ADDENDUM NO. 1

South Walnut Street (Winslow to Ridgeview) Sidewalk Project

Issue Date: November 30, 2021

Item No. 2: ADDITIONAL INFORMATION OR CLARIFICATIONS – INSPECTION HOLES

BRCJ Project No: 10525
 Inspection Hole Locations

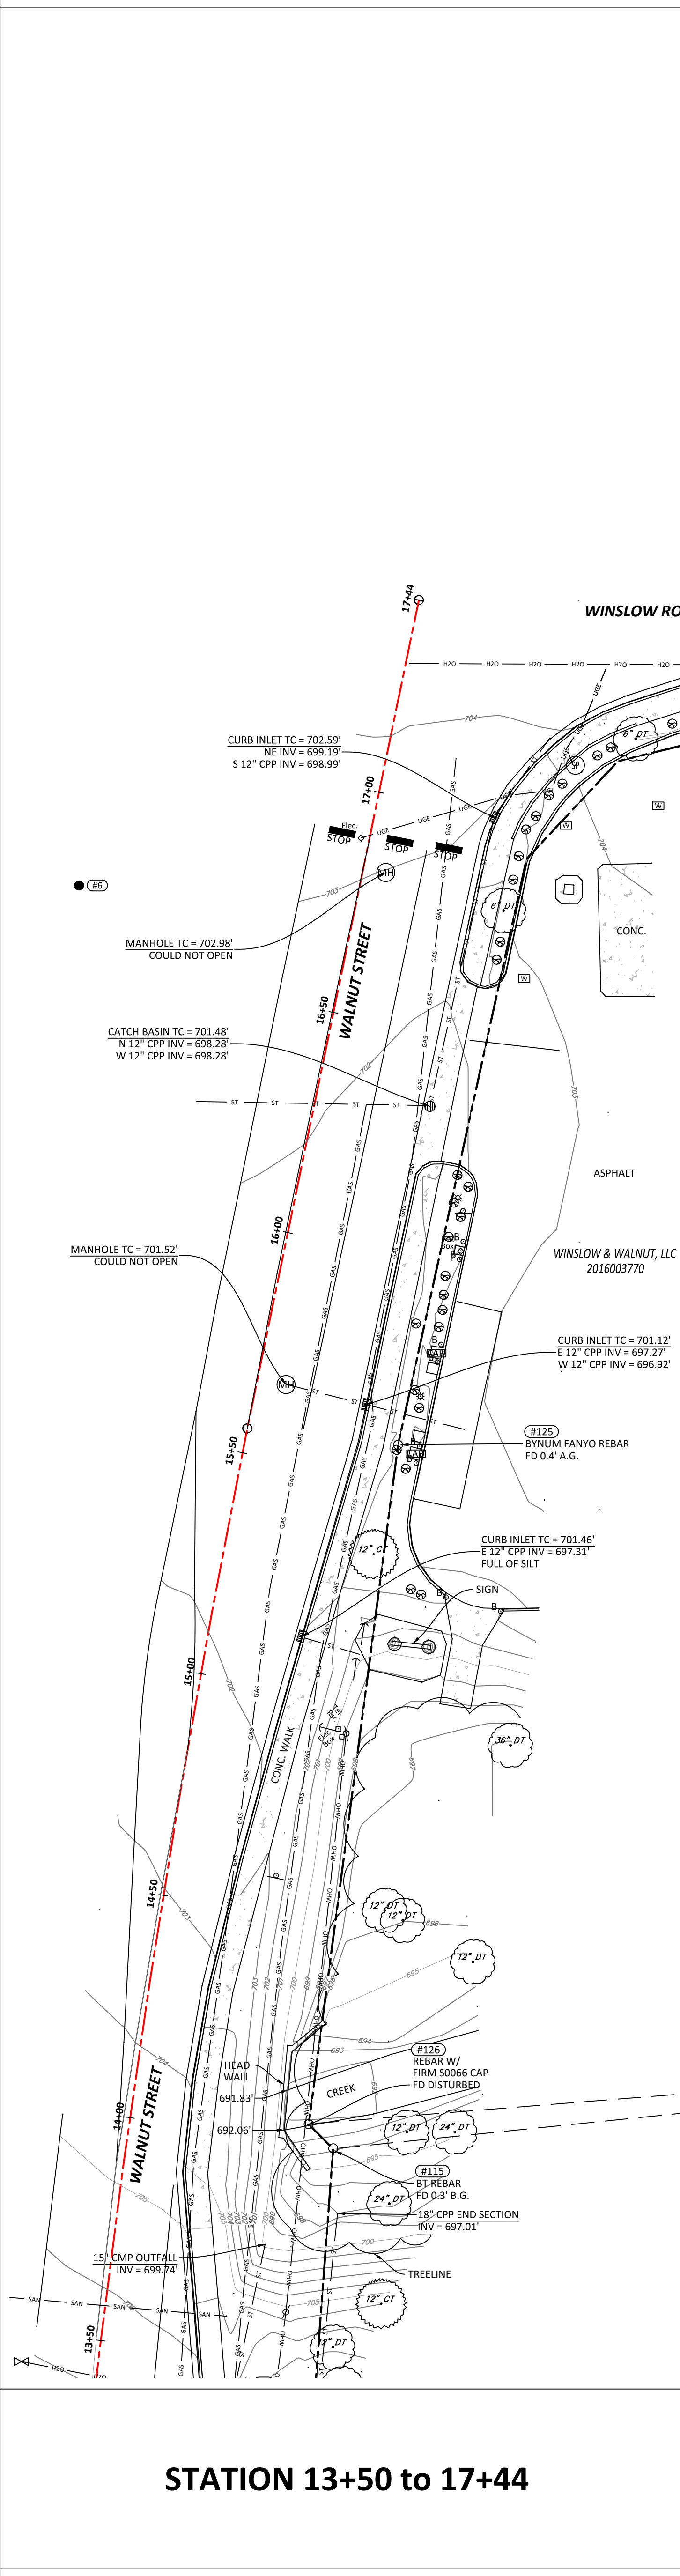
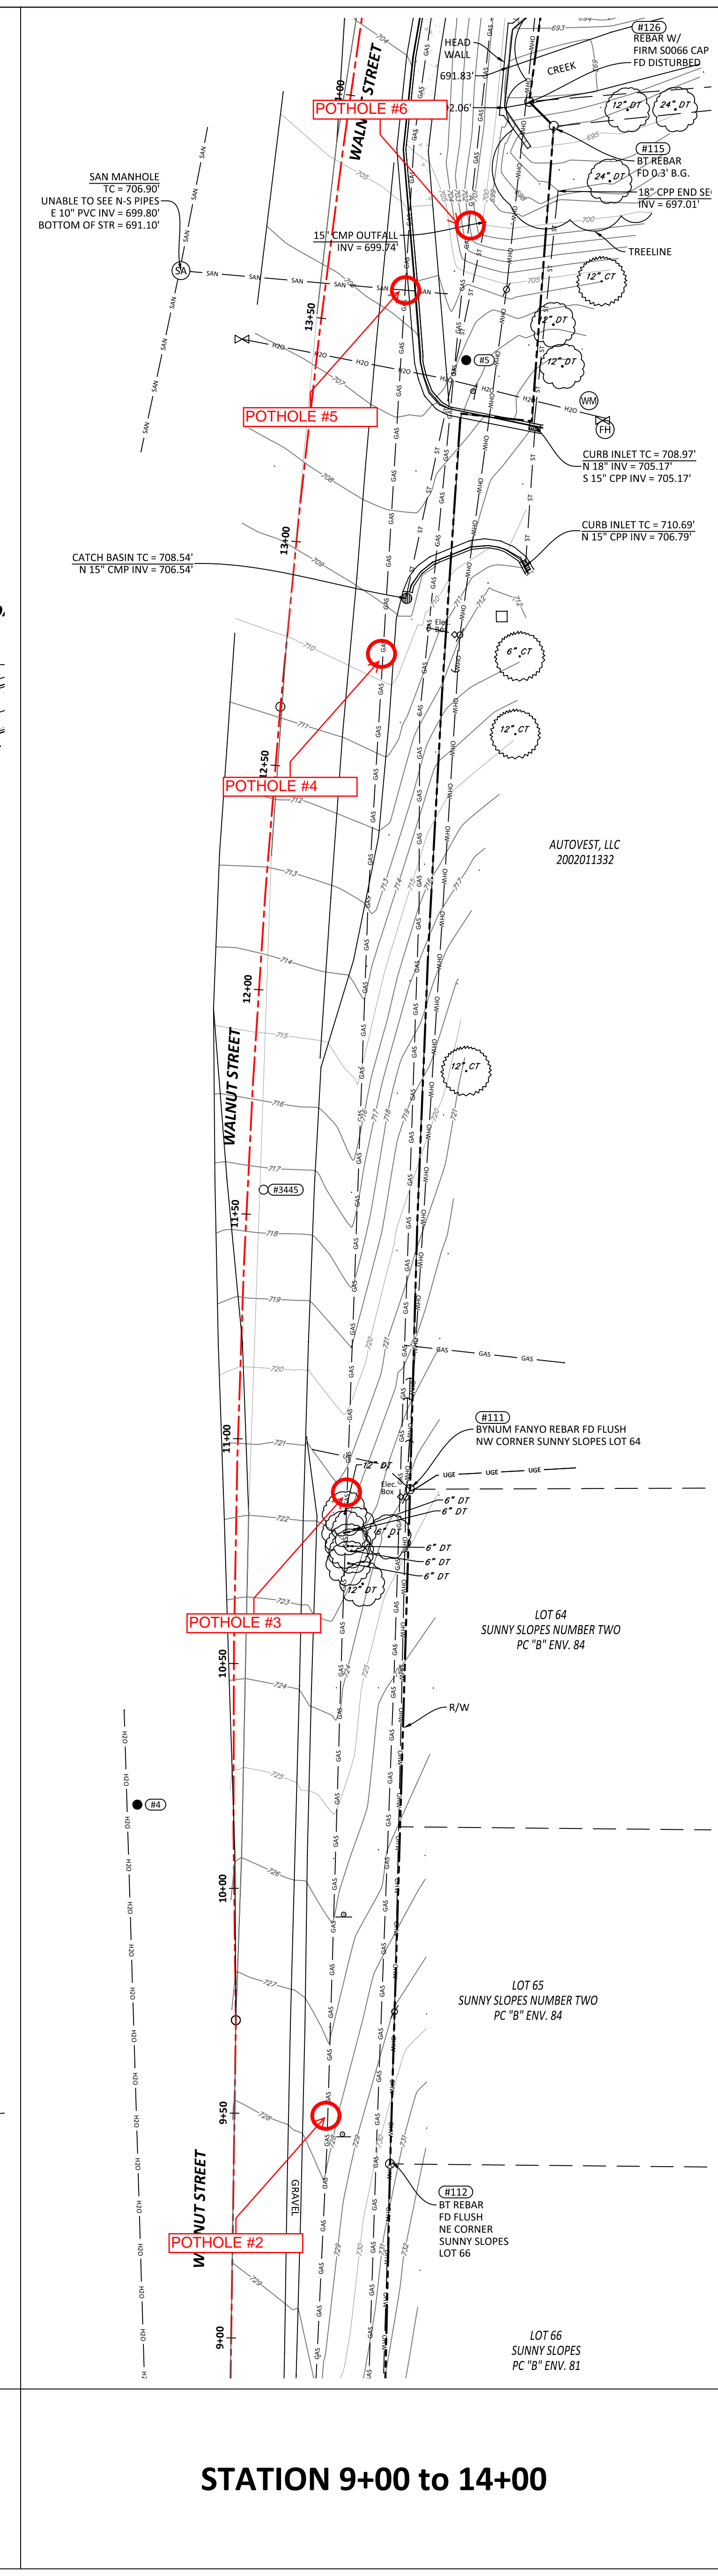
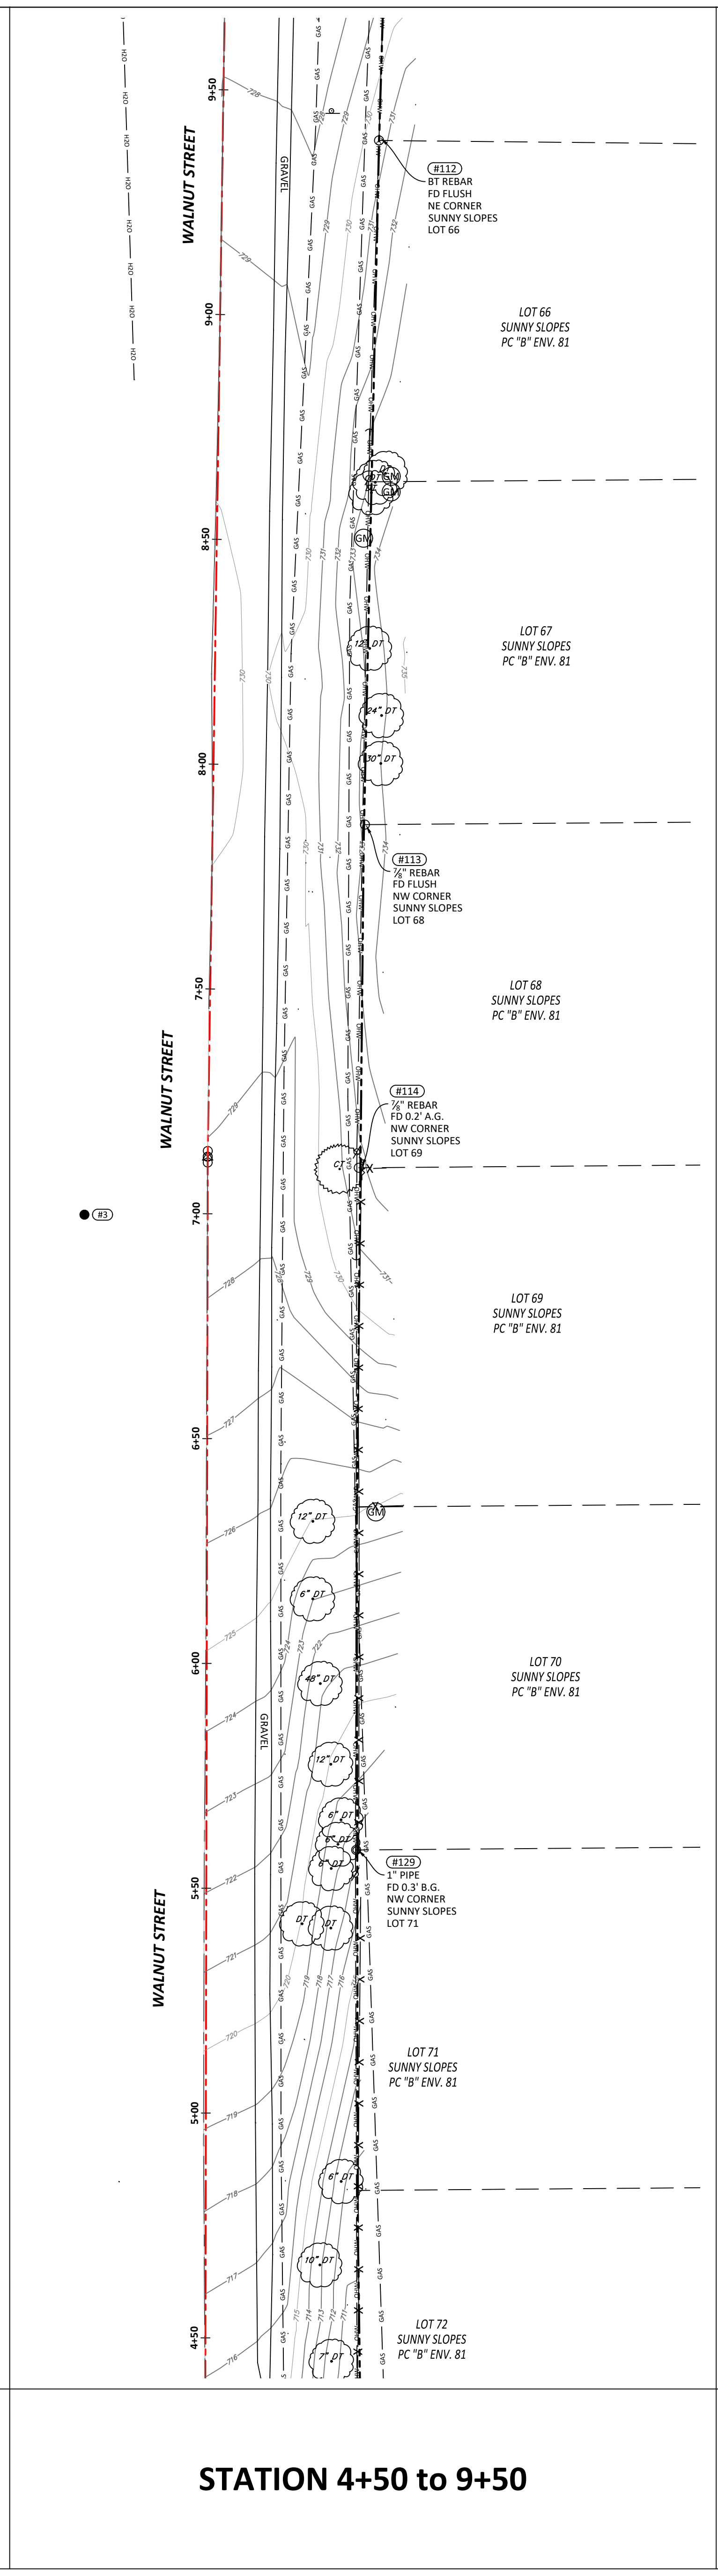
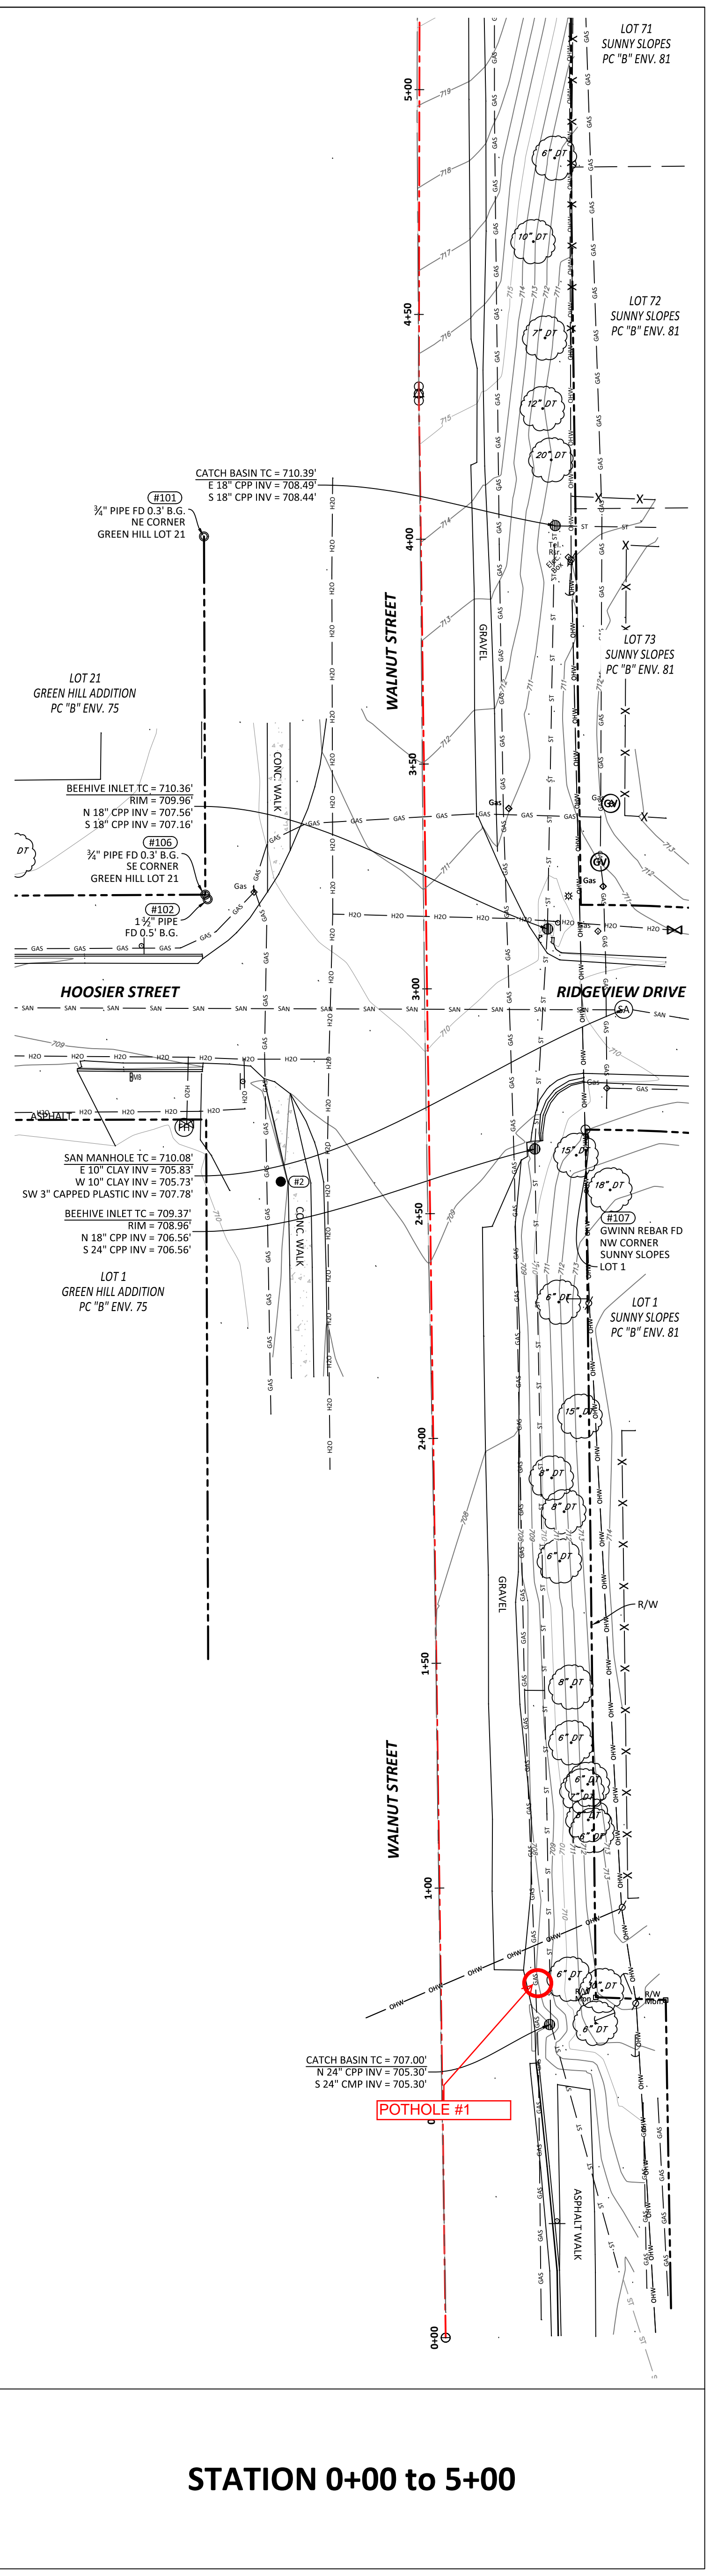
The Contractor shall complete inspection holes to verify the depth and location of gas lines prior to ordering stormwater structures. Required inspection hole locations are provided in the attached document. The results of the inspection holes shall be provided to the Engineer at least ten days before the contractor orders materials. If unexpected conflicts are identified, then the Engineer will provide updated structure information to the Contractor. Inspection holes will be paid for at the contract unit price per each, Pay Item: 107-09358 Inspection Hole, Deeper Than 3 FT. The cost of all work pertaining to inspection holes shall be included in the cost of this pay item. Inspection hole work will have no effect on the allowable project duration days. The contractor shall be fully responsible for any delays or additional costs that arise if inspection holes are not completed as directed within this item.
